Attachment 1

Proposed Changes to  
Technical Specification Pages

Unit 1

Unit 2

Figure 6.2-1 Offsite Organization for Facility Management and Technical Support

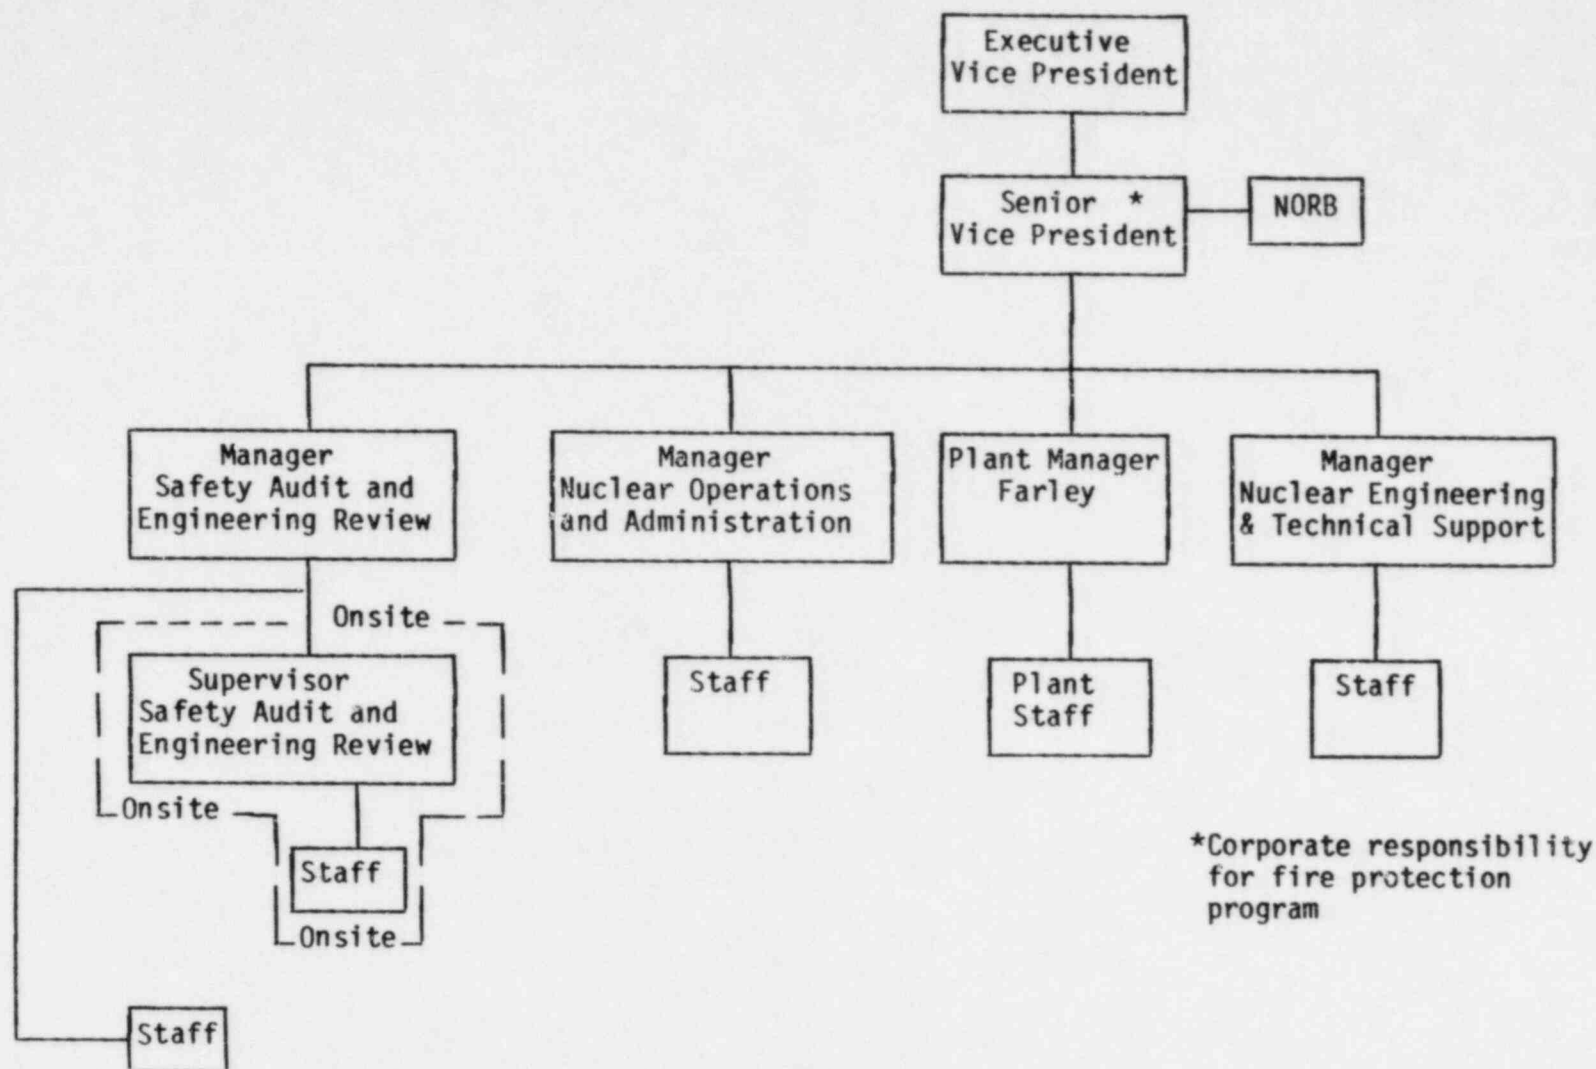
6.2.1 The offsite organization for facility management and technical support shall be as shown on Figure 6.2-1.

Figure 6.2-1 Offsite Organization for Facility Management and Technical Support

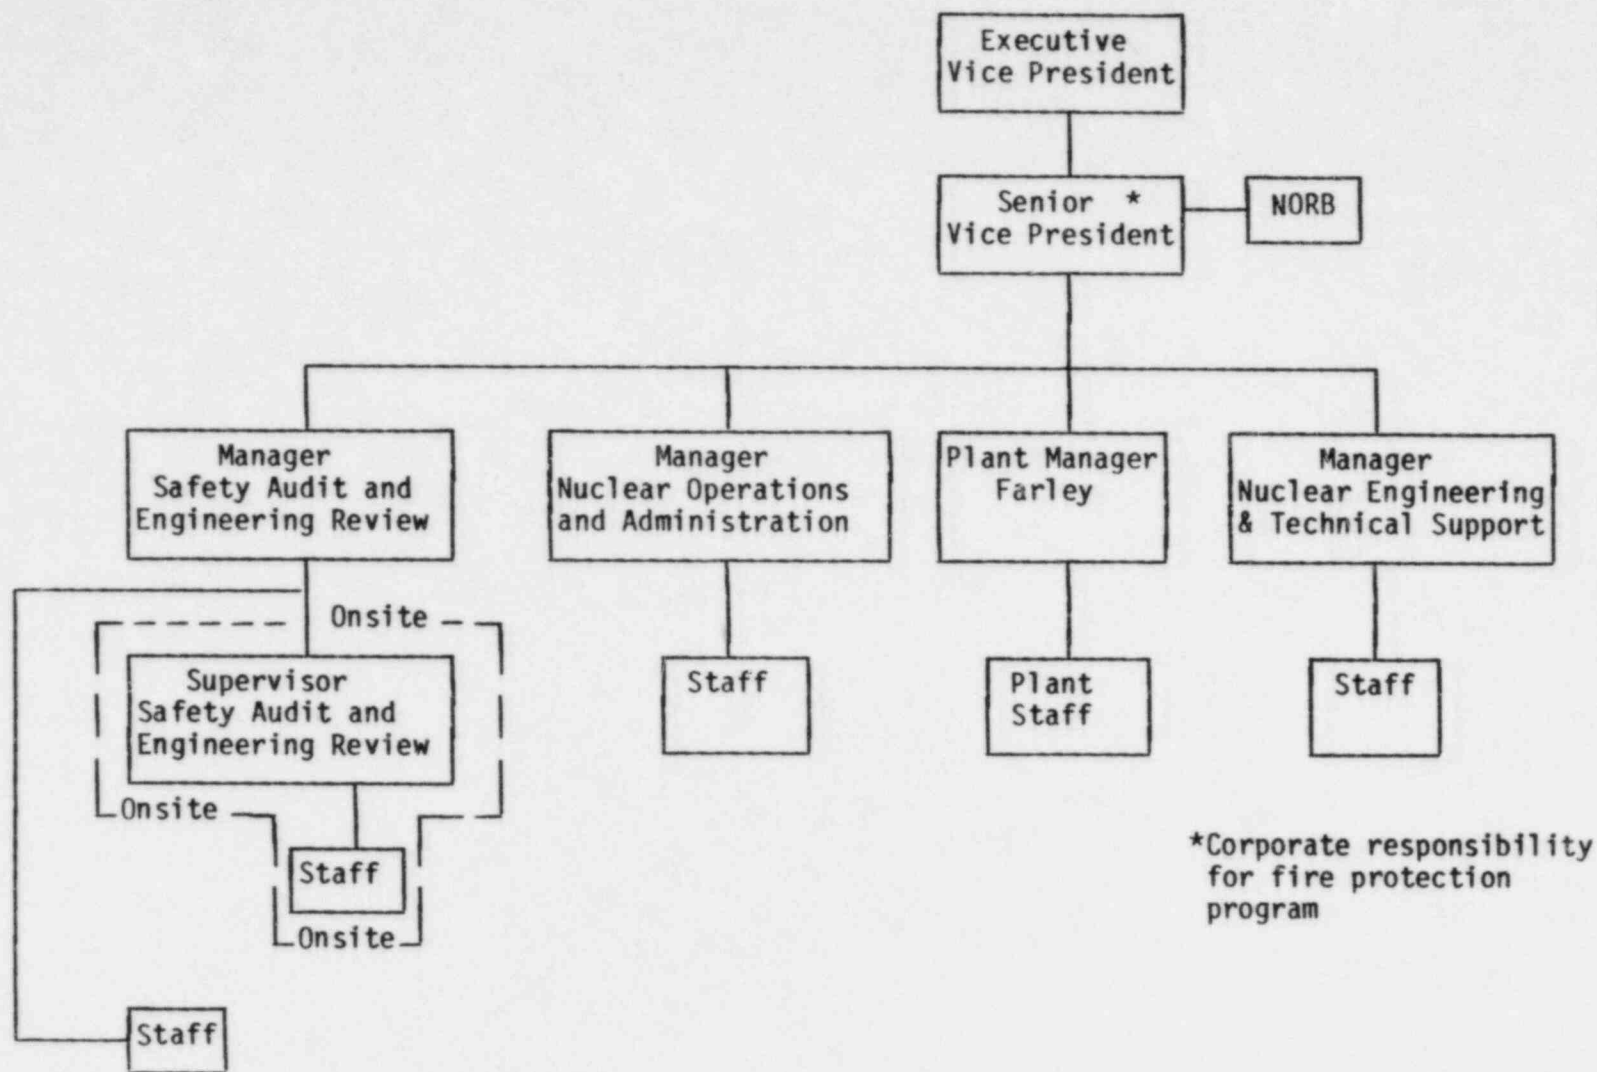
6.2.1 The offsite organization for facility management and technical support shall be as shown on Figure 6.2-1.
